GENERAL

This addendum forms a part of the Contract Documents and modifies the original Bidding Documents dated November 2024 and consists of pages AD2-1 through AD2-10 The following changes, additions and/or deletions shall be made to the following documents: all other conditions shall remain the same.

ITEM NO. I – CONTRACT DOCUMENTS
ANNOUNCEMENT TO PREQUALIFIED BIDDERS
SUPPLEMENTARY INSTRUCTIONS TO BIDDERS

PROJECT SITE
DAVIS TOWER (BLD-1445)
1ST FLOOR
2315 STOCKTON BLVD,
SACRAMENTO, CA 95817

2 1ST FLOOR RCP - DEMOLITION

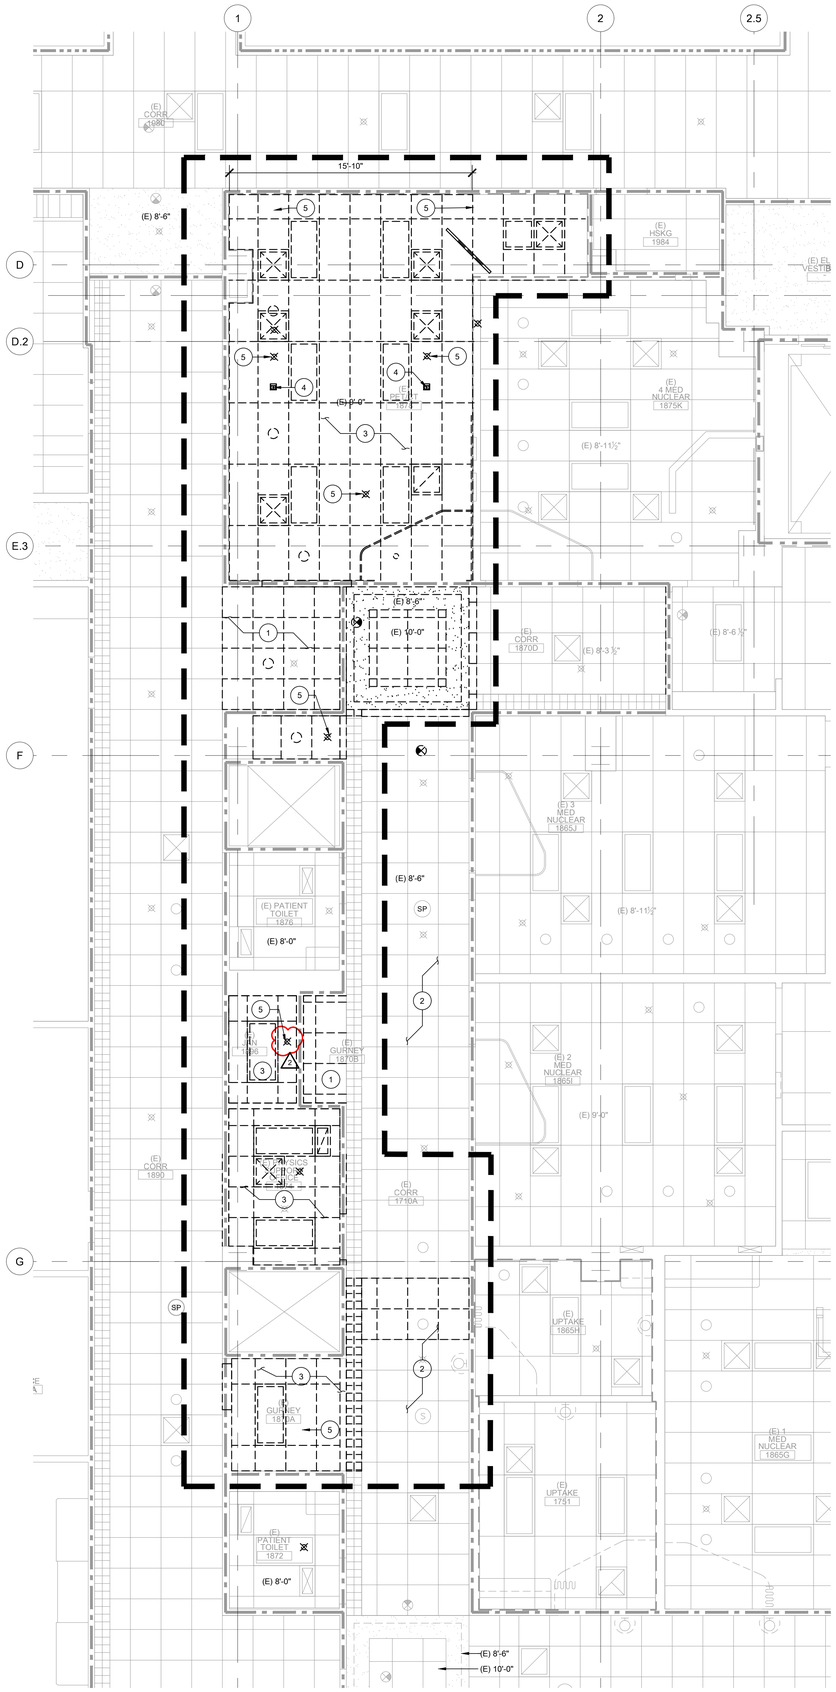
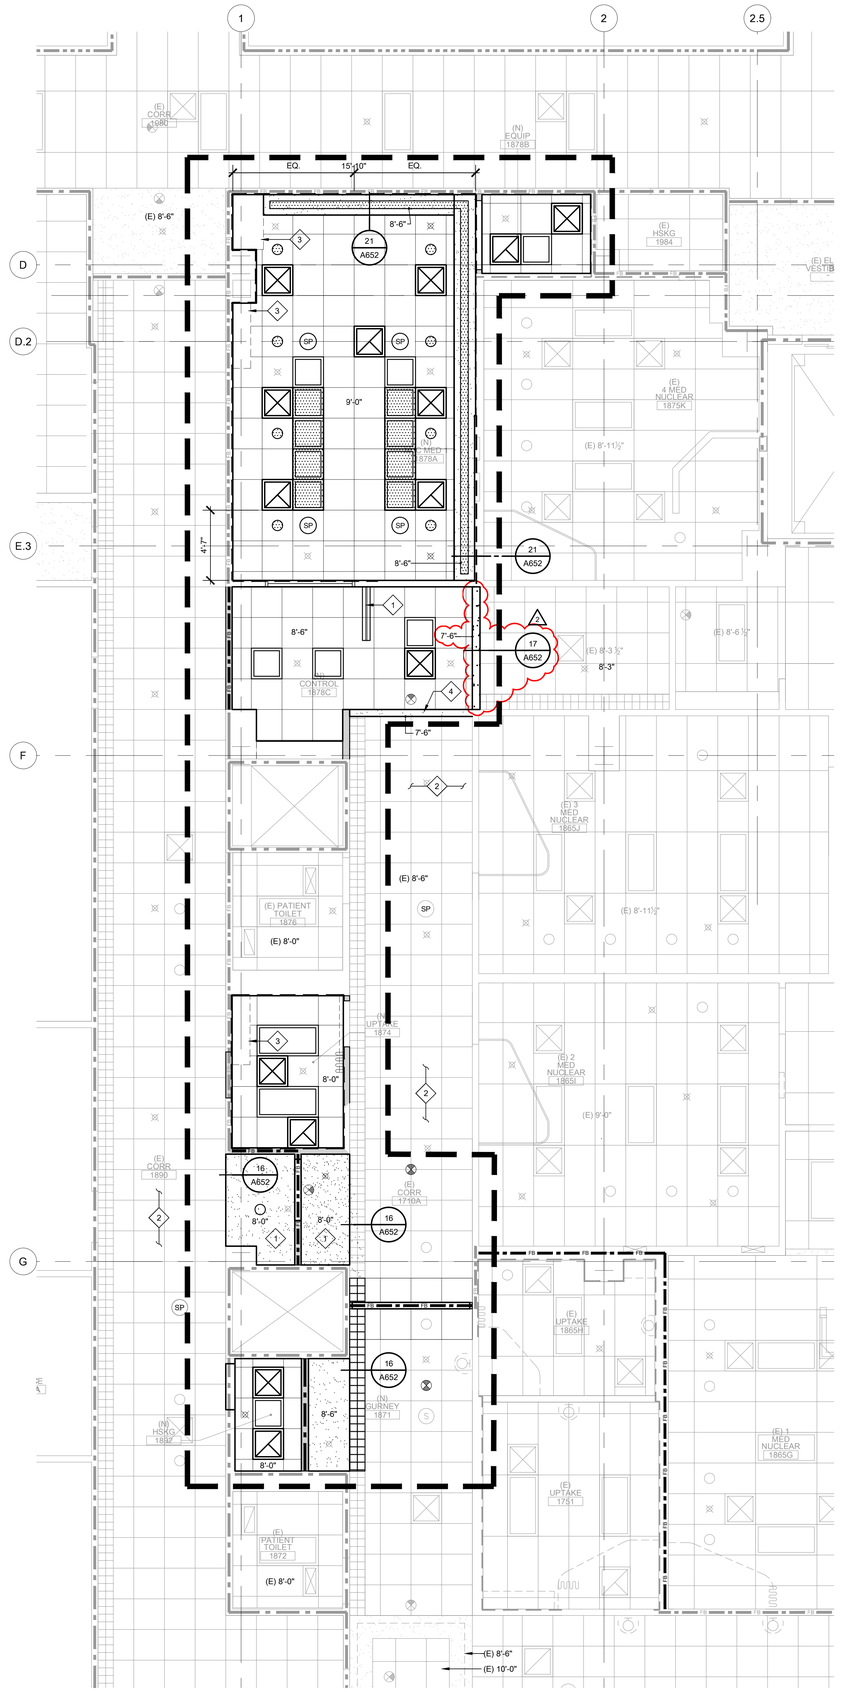
RFI #24: Demolition Keynote 5 /A541A calls for "CEILING ITEMS TO BE RELOCATED," but does not point to any specific item on the Demolition Plan. Please clarify on what the ceiling item(s) to be relocated are.
Response: This was a graphic error. See revised sheet A541A.

RFI #50: Sheet A541A - Please provide a detail on how the existing T-Bar & (N) T-Bar grid will transition at the corridor Northwest of Room 1865J?
Response: See revised sheet A541A.

21 SPECIALTY LED @ PERIMETER

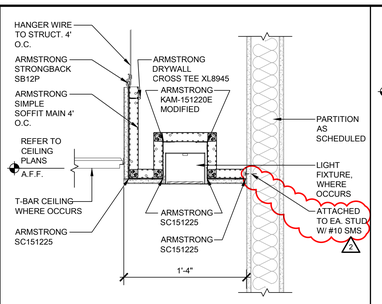
RFI #18: Detail 21/A652 includes an Armstrong SC151225 attachment to partitions for Specialty LED Light Fixtures, but does include how it attaches. Please clarify the attachment requirements.
Response: See revised sheet A652, detail 21.

1 AREA A - EQUIPMENT PLAN

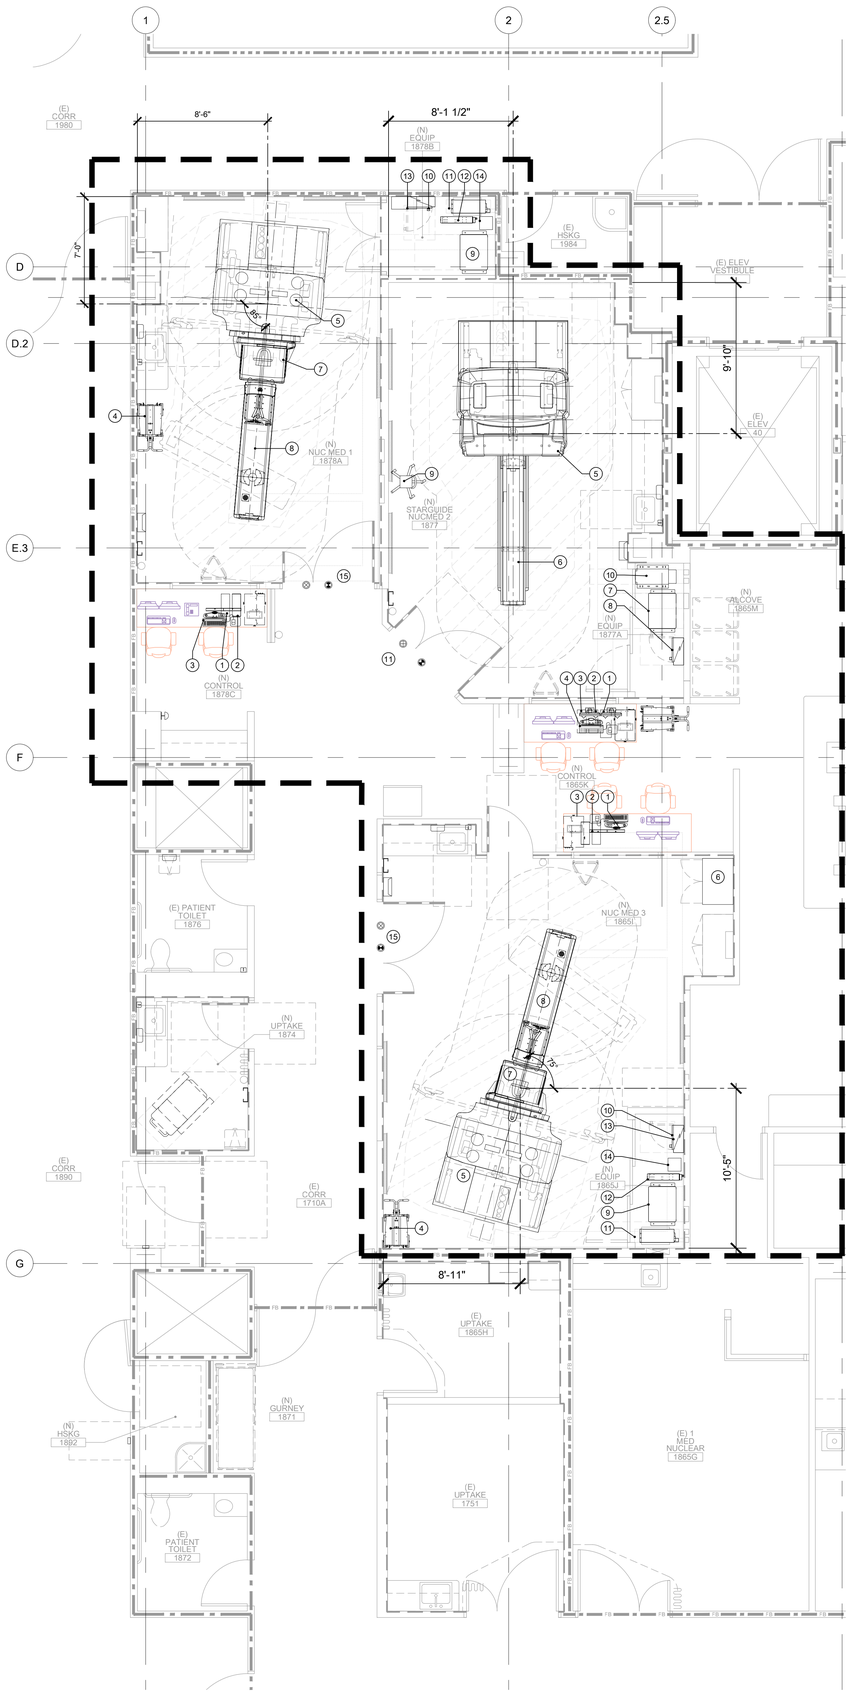
RFI #9: Sheet A831 - Confirm items marked as 'A' is Supplied and install by GE. Contractor is to furnish access per item 'C'. Main Rad Equipment is by GE.
Response: See revised sheet A831.

RFI #10: Sheet A831 - Confirm on Rm 1878A item 7 should not be marked 'B'. It should be supplied and installed by GE same as in Room 1865.I item 7 both are NM Gantry (without Collimators- wt is 4251lb).
Response: See revised sheet A831.

RFI #36: E311A indicates the MDP is to be ordered from GE. Item 14 on drawing A831 for Room 1878A indicates the MDP is supplied by GE as part of their order. Please clarify if bidders are to buy the MDP from GE or if UCDH is purchasing this item with the GE package. If bidders are to buy the MDP, please provide contact information for GE. This is typical for a number of items, such as UPS, in all the imaging rooms..
Response: MDP and UPS are GE supplied. See sheets E311A, E312A, & E313A, note for ordering from GE has been removed. See Sheet A831 for clarification of GE supplied equipment.

DETAIL 1 S-201 — 1 1/2" = 1'-0"

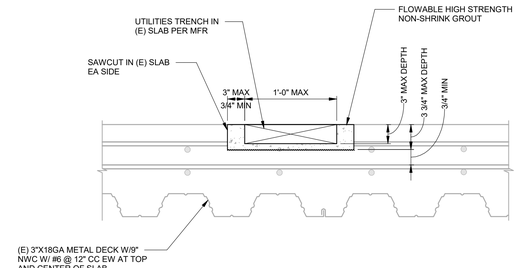
RFI #21: Please confirm if the Non-Shrink, Non-Metallic Structural Grout referenced in Detail 6/A640 is to be used for the trench duct infill locations as seen on Sheets A511A, A511B, and A511C.
Response: Yes, non-shrink structural grout is for trench duct infill. Also reference detail 1-S201 provided Bid Addenda drawings.
